Notice of Project Change

THE HUB ON CAUSEWAY

OFFICE TOWER

February 2018

FIGURE 3-2 FULL PROJECT BUILDING SECTION

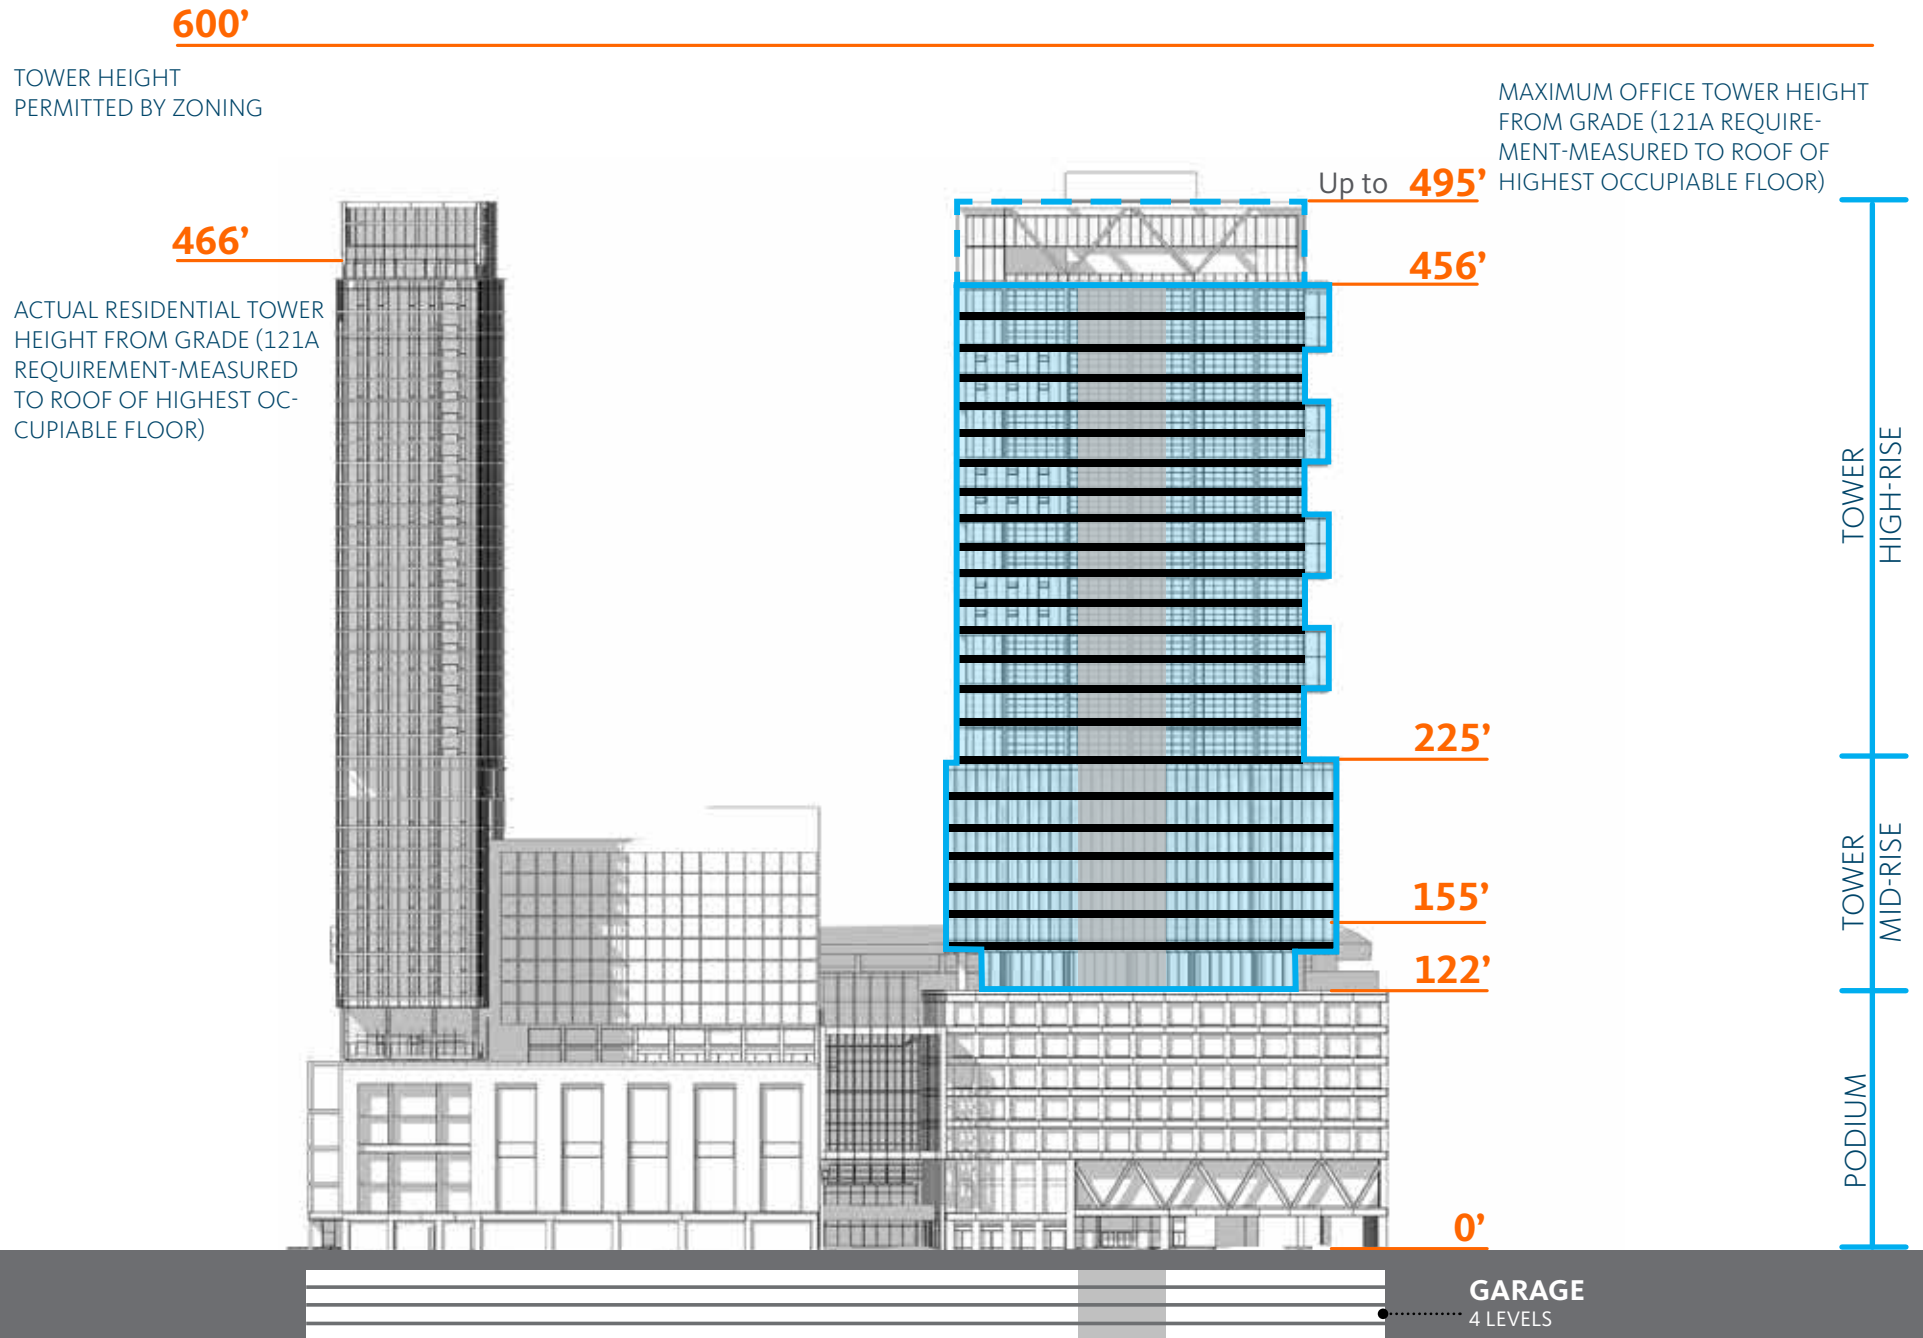
- **Higher Floor to Floor Heights** (13'-6 floor to floor typical)
- **Floors with Increased Ceiling Heights** (20'-0" + floor to floor on 8, 15 and 16 for amenities, gathering and maker spaces)

From a quantitative standpoint, the Office Tower has at least 16,500 square feet *less* overall GFA than originally planned and approved. The decision to include within the Office Tower the design amenity of an occupiable roof deck has added about 30 feet of additional "height" to the structure and an additional "story." In the prior design, the top floor was limited to mechanical equipment and therefore excludable from the height and story calculation.

the physical height of the building. Overall, with the higher floor to ceiling expanses and the addition of one floor, the physical height of the Office Tower would be increased by about 45 feet (note: height calculated pursuant to the Boston Zoning Code would increase by approximately 75 feet). The increase in actual height, along with the expanded maximum floor plates, would result in a small extension of shadow, particularly during early morning, early evening and wintertime, when sun angles are low. Much of the additional shadow falls on areas such as the train tracks or areas already in shadow from other buildings. The updated Shadows Studies from the previous PNF Supplemental Information submittal dated December 6, 2013 (See Figures 4.B.1 through 4.B.13) show the previous Office Tower shadows in orange, with the proposed building shadow outlined and infilled with yellow. Changes in shadow are due in part to the different height, massing, positioning and orientation of the Office Tower on the Podium, and as mentioned above, are most differentiated when sun angles are low.

FIGURE 4-A-2 MEAN WIND SPEED - FULL BUILD, ANNUAL

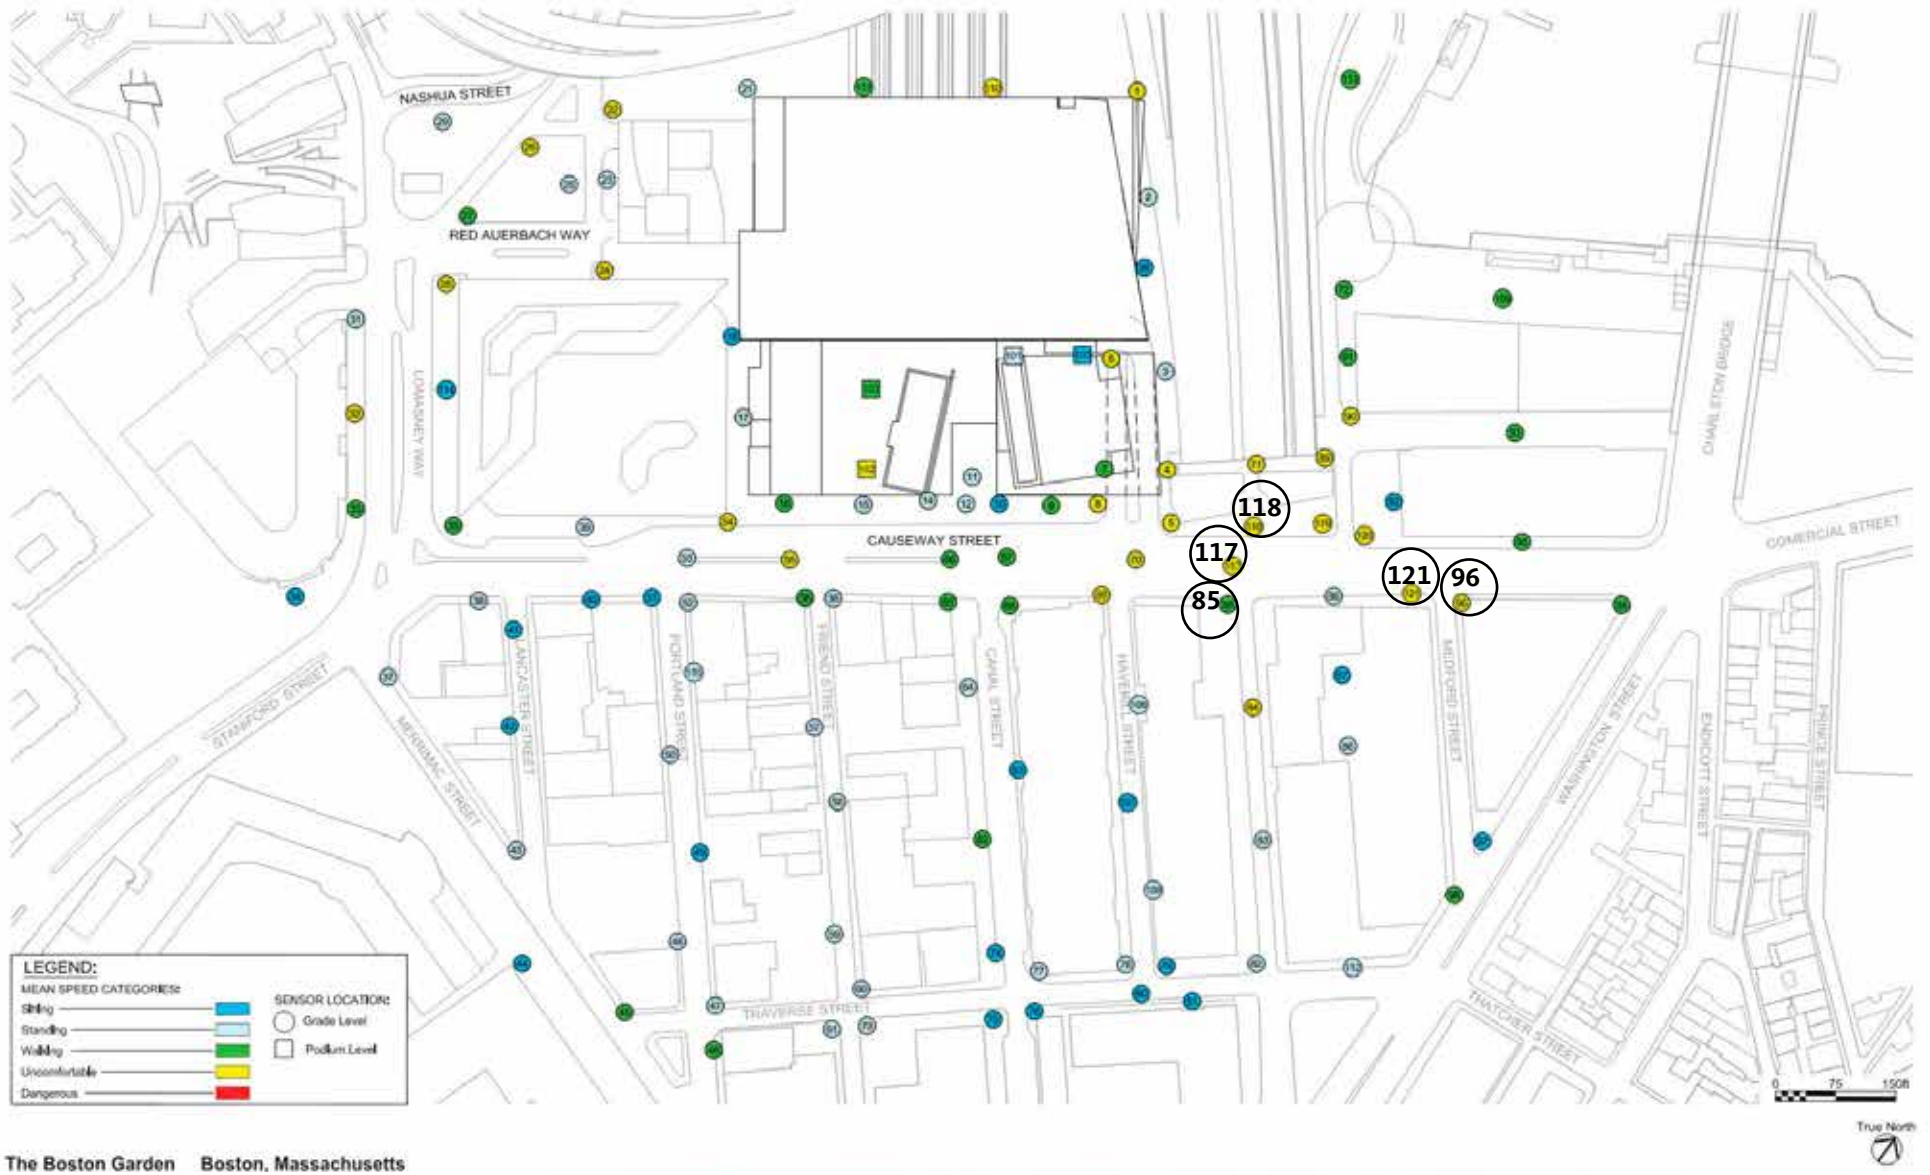
The proposed design has been reviewed by Rowan Williams Davies and Irwin Inc (RWDI) and compared to the test conducted previously as part of the PNF Scheme included in the December 6, 2013 PNF Supplemental Information for both the No Build and Full Build Condition. As noted in the enclosed RWDI memo, the conditions at the pedestrian level are similar in nature and have actually improved in some areas. See Figure 4.A.1 RWDI Wind Memo dated January 26, 2018 for the further analysis.

In general, the wind comfort conditions at grade remain unchanged or improve with the new tower in place compared to previous conditions. This is likely due to the large balconies incorporated into the new design which helps disrupt or confuse the wind shedding off the tower. Provided below is Table 1 which shows the wind conditions at two key locations adjacent to The HUB. The wind conditions at these locations can be considered as representative of other locations at grade level adjacent to the Development.
